## PLAN CHANGE 25 – RURAL LIFESTYLE ZONES

**Submission to Mackenzie District Council (MDC) on Plan Change 25 (PC 25)**

**B.D. and C.B. White submission on Plan Change 25 and the Rural Lifestyle Zone**

# Option 2.1 – 13 only Properties funded by MDC

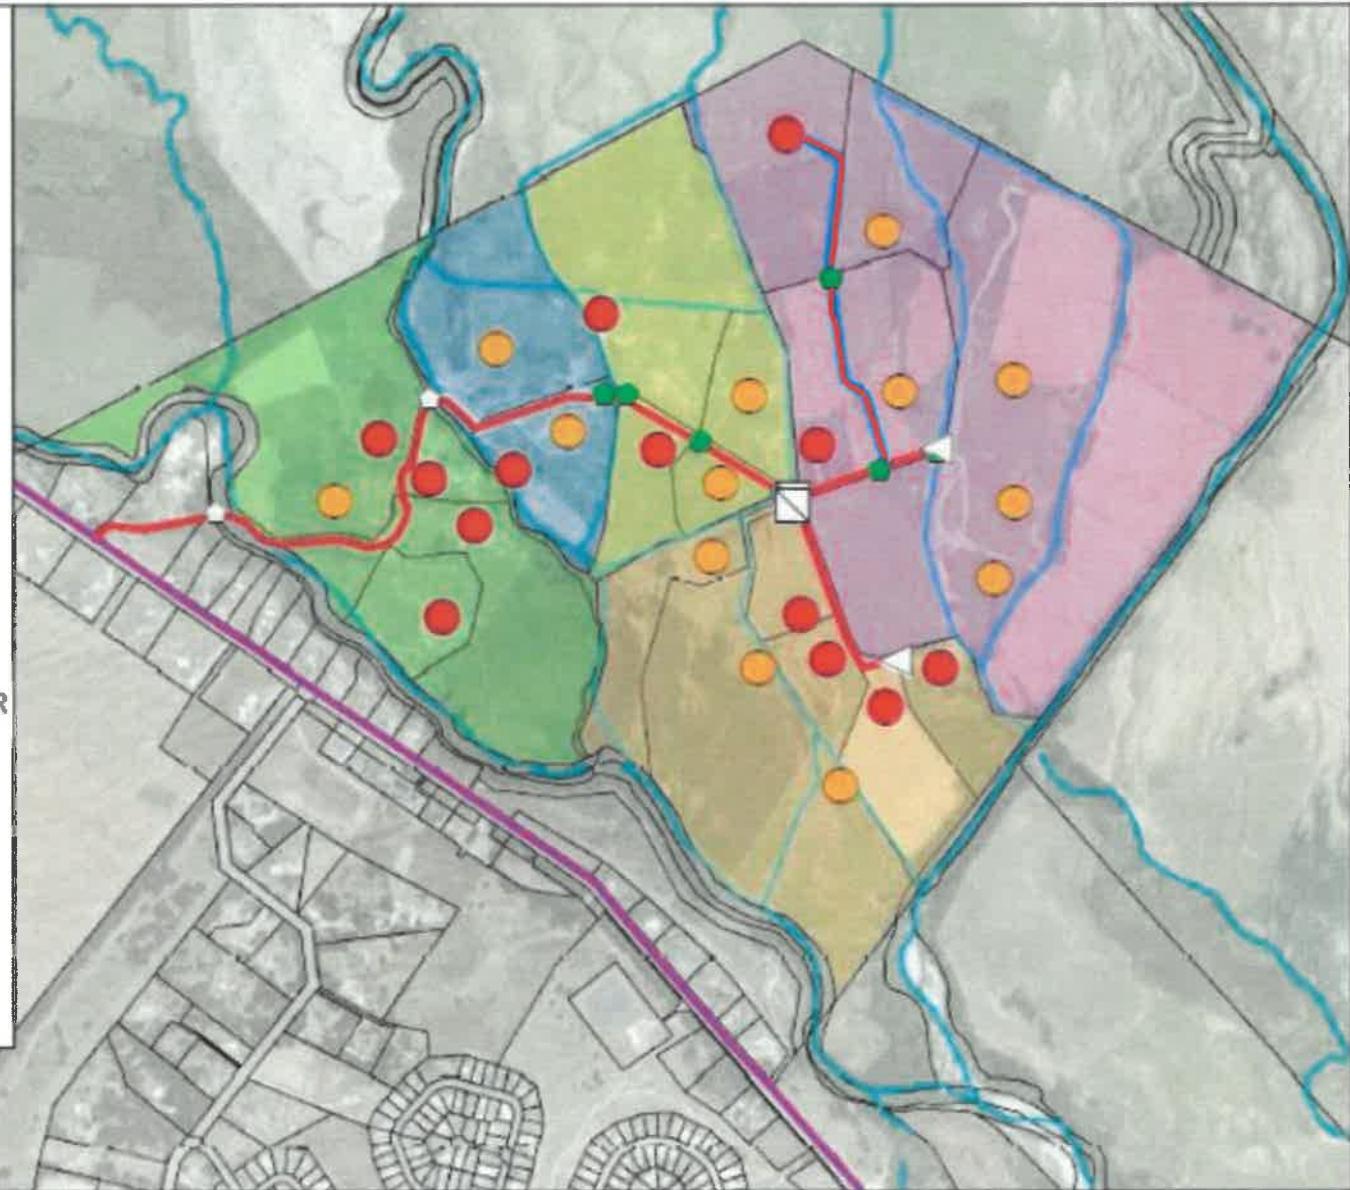
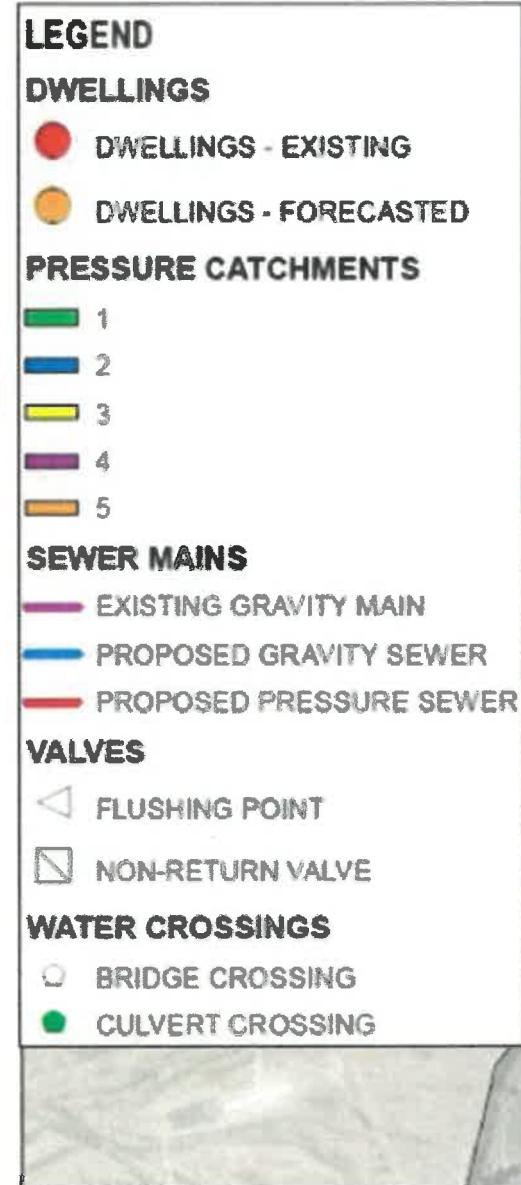
Strikes me this proposal you want us + sign on is 'lost'

You haven't <sup>and passing</sup> allocated your proposal thru to existing rate payers / future builds  
consider your zone, yet for want us to pay  
lets do it now, do it right

Figure 3-15: Maximum modelled water depths for a 50 year ARI flood event

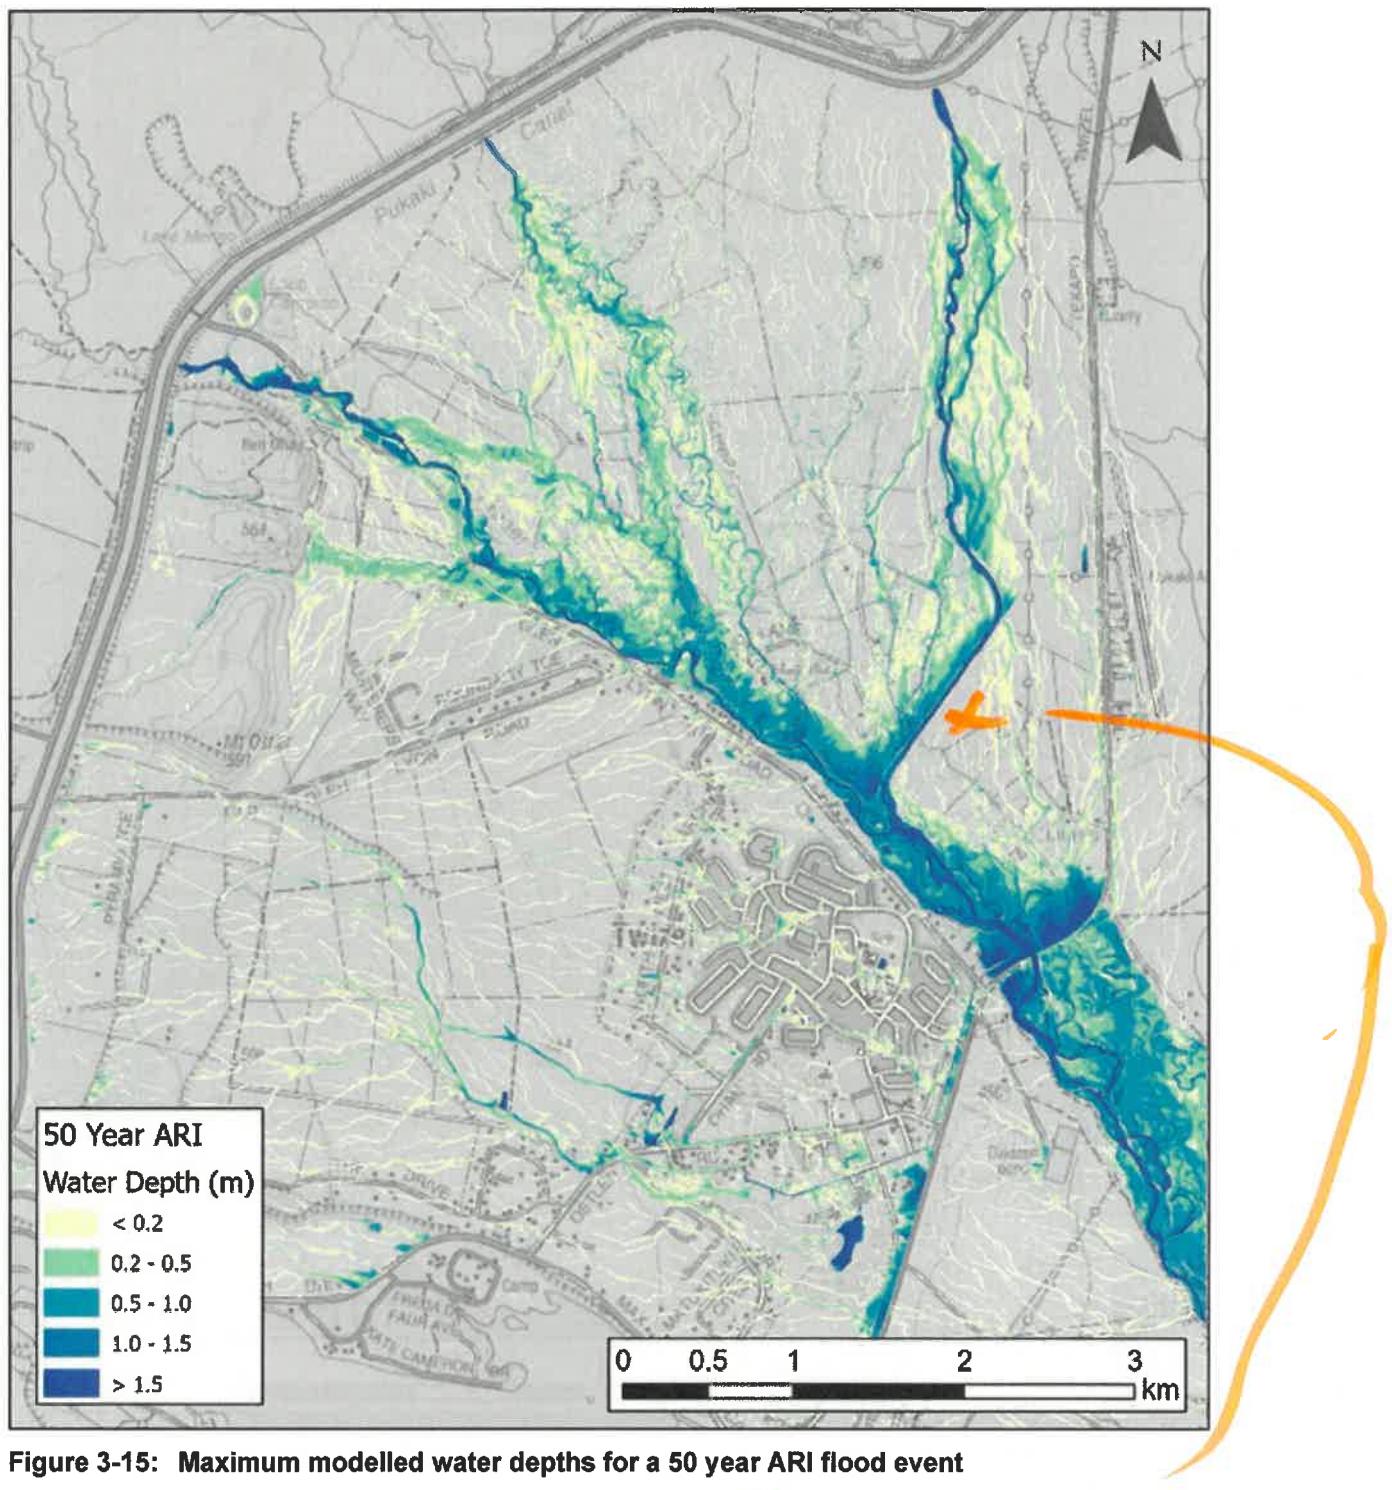
1 event? since 186

*Look at contour map*

Figure 3-16: Maximum modelled water depths for a 100 year ARI flood event

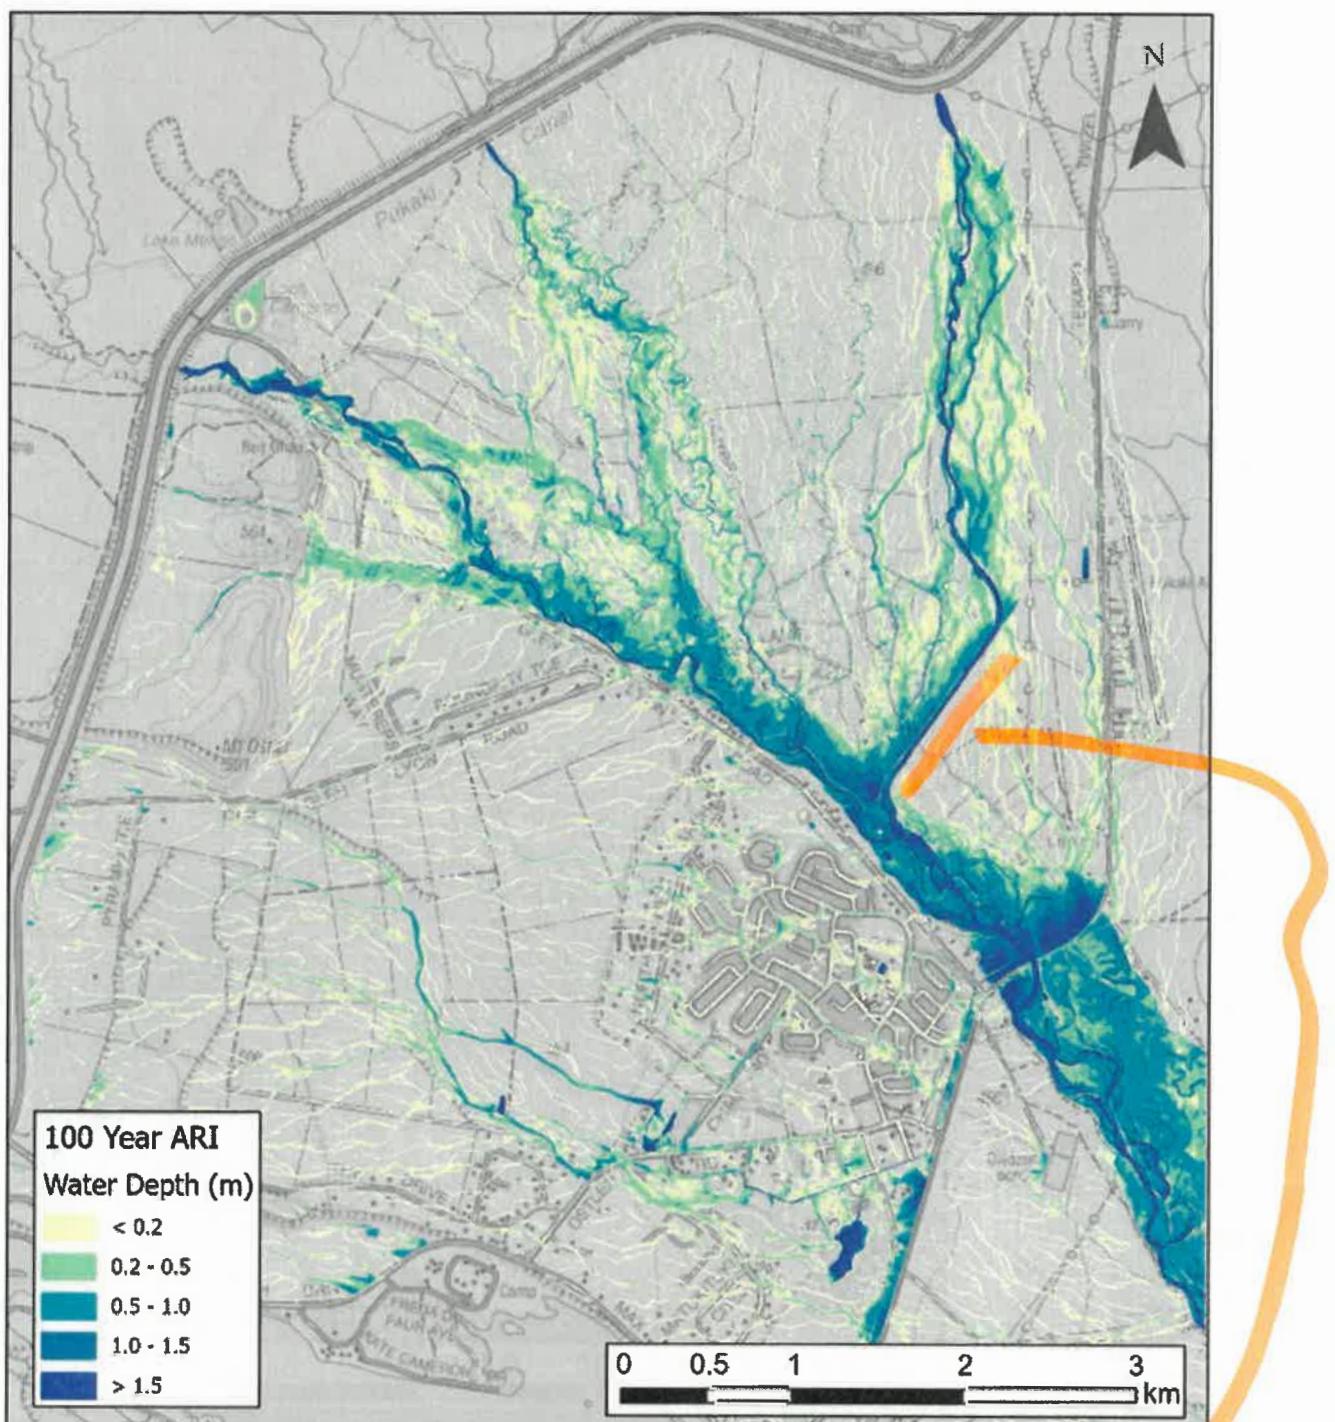
No Water??

Figure B-3: Twizel River looking north-west from SH8 May 2009

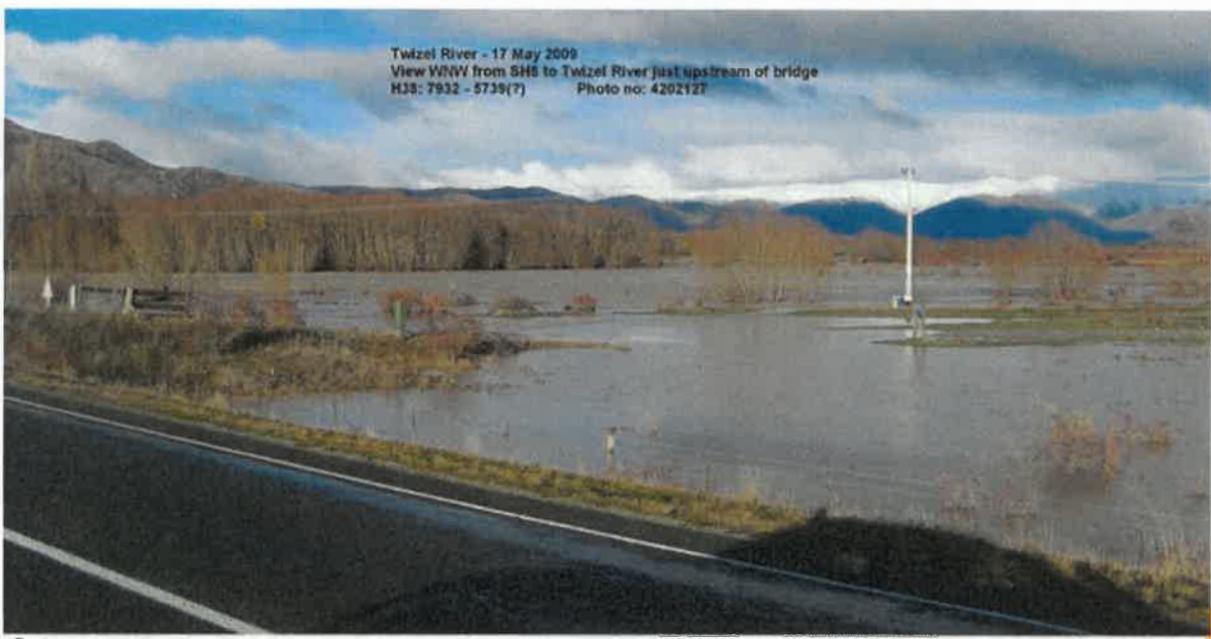
We disagree with the Ecan 'Twizel flood modelling investigation' desktop flood analysis in several areas and several of their comments made in their March 2023 submission around plan change 21. They use wrong pictures in their report to describe the Twizel River. For example use a picture of the Ahuriri River at SH8 in Figure b-3 of their report and describe it as Twizel River flooding.

exports not picked  
this up **Not Twizel R**  
**Ahuriri Rver.**
